ITEM FOR ENVIRONMENTAL BOARD AGENDA

**NAME & NUMBER
OF PROJECT:** 2908 SCENIC DRIVE
SP-2013-0295DS

MEMORANDUM

SUBJECT: 2908 Scenic Dr. SP-2013-0295DS

View of proposed tram route

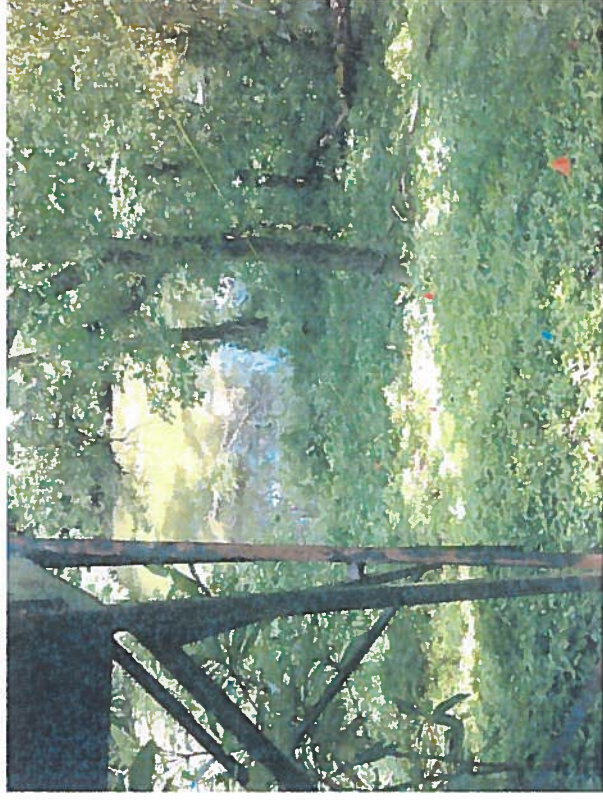
CEF at proposed tram crossing

Rimrock and existing shoreline access

Existing shoreline access

Proposed tram location
